**Our ref: NI2422 Largs - EIA Screening**

**Request for an EIA Screening Opinion under Regulation 10(1), Part 2 The Marine Works (EIA) (Scotland) Regulations 2017 (Further Information)**

**Proposal: Replacement Seawall, Largs Bay, Largs, North Ayrshire**

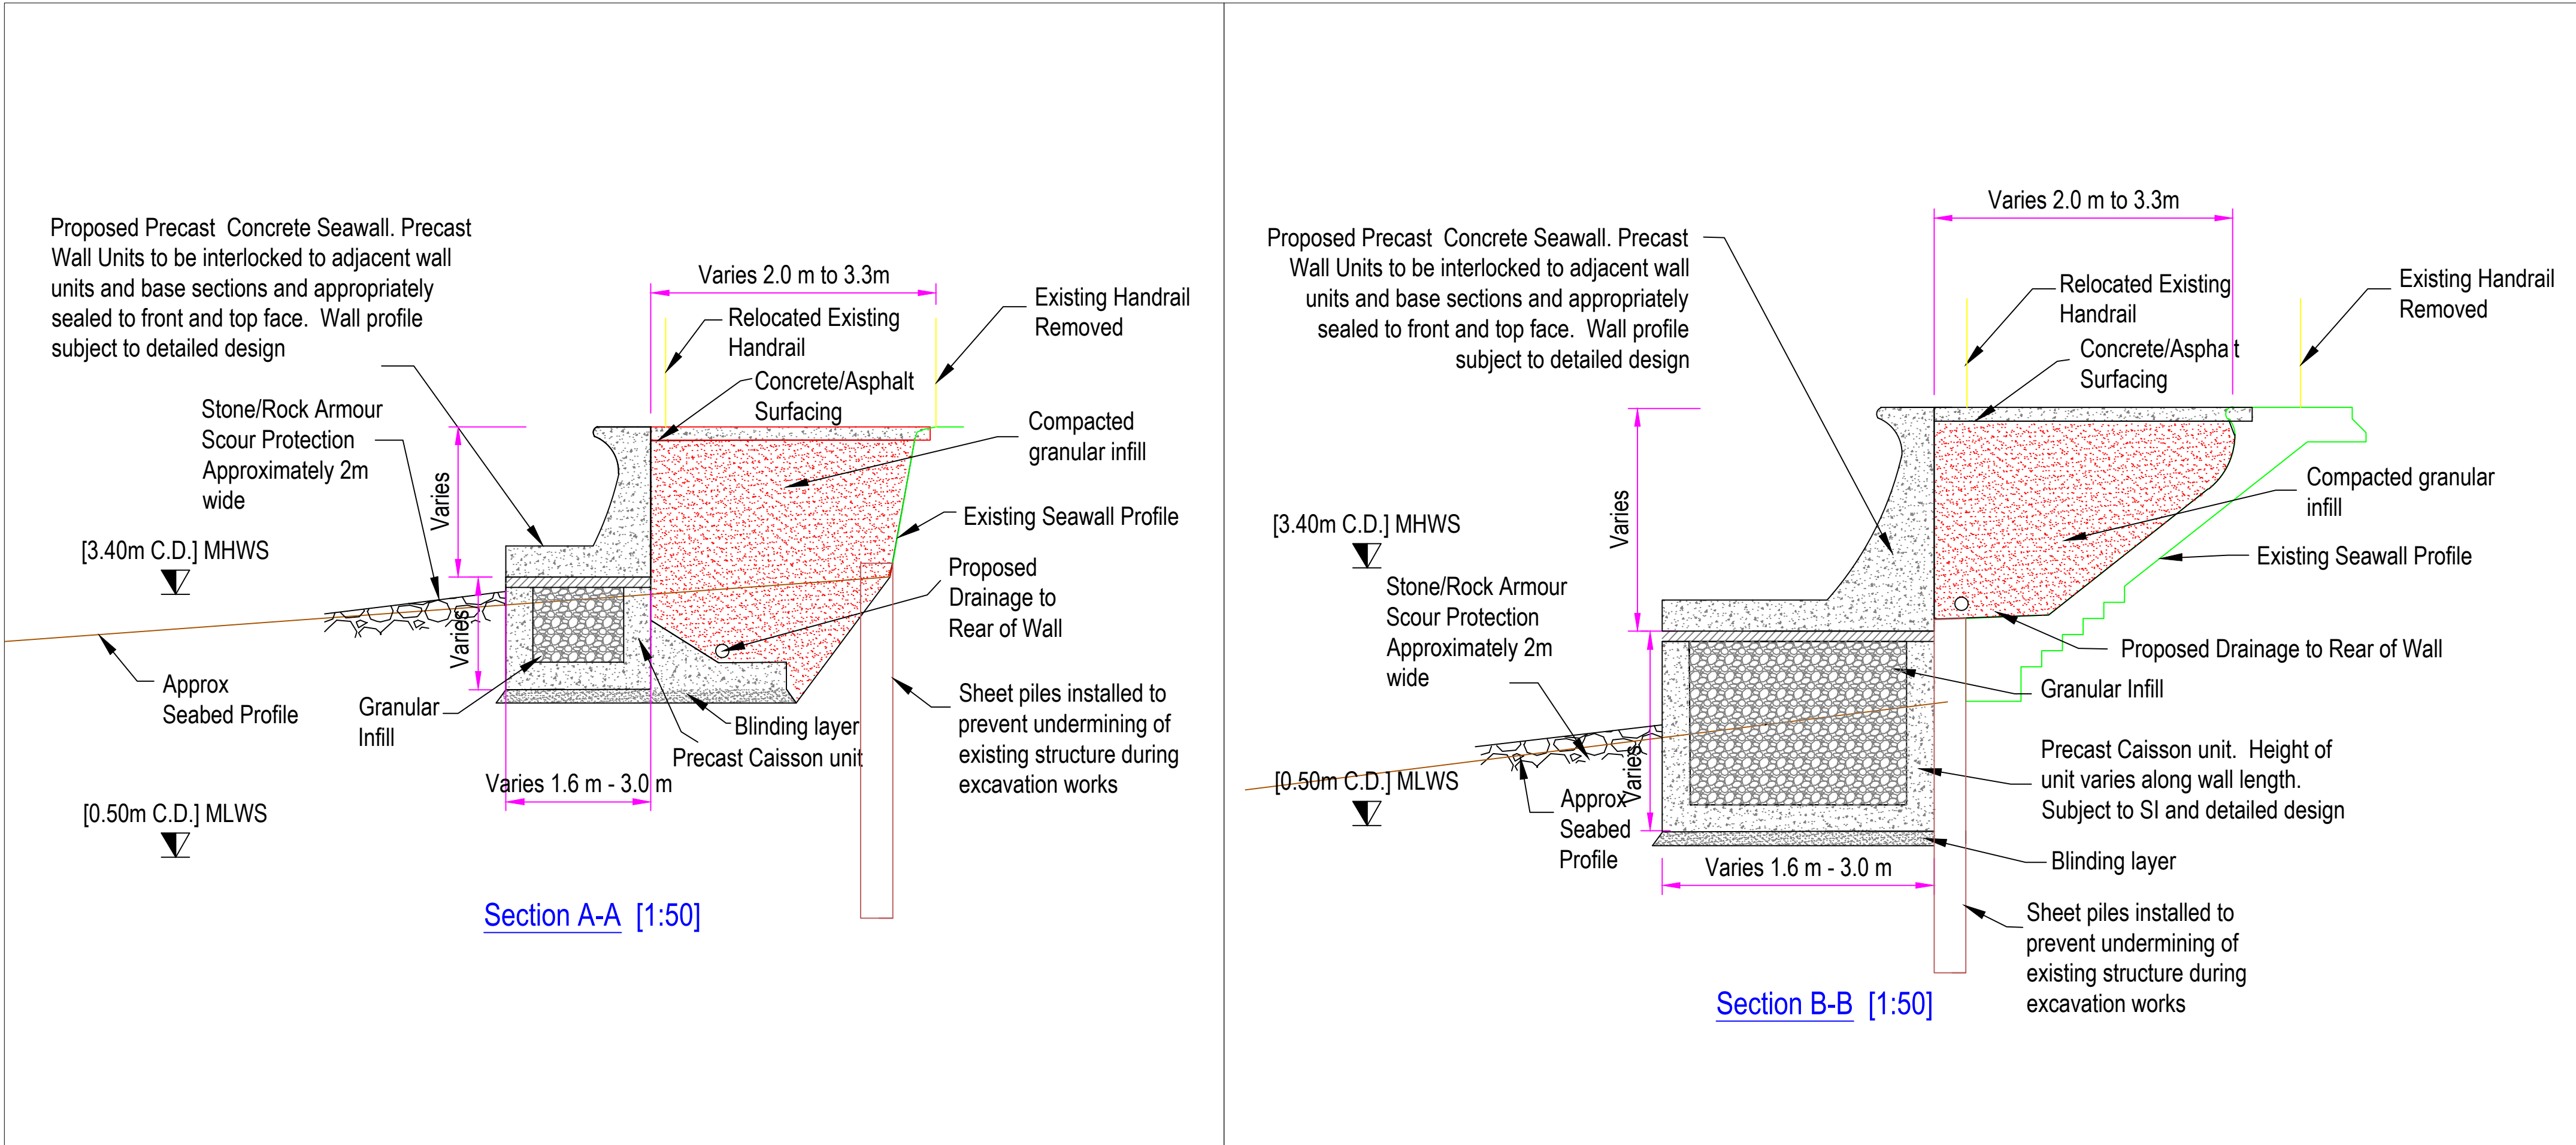
***Section 2.3.9 states that the proposed works will have no impact on coastal processes. Please provide evidence of the modelling which supports this, including information as to how wide the replacement wall concrete sections are to be and approximately how wide the area of scour protection installed at the base of the new wall is to be. This element of the report requires to be detailed and robust as the proposed works are being screened under Section 10(m) of Schedule 2 of The Regulations which is the section referring to projects which may be capable of altering the coast.***

The dimensions of the proposed concrete wall sections and the scour protection have been added to the Cross-Section drawings, which are enclosed at **Appendix B**. The potential impacts on the various constituents of the coastal process regime in the area are considered in further detail below.
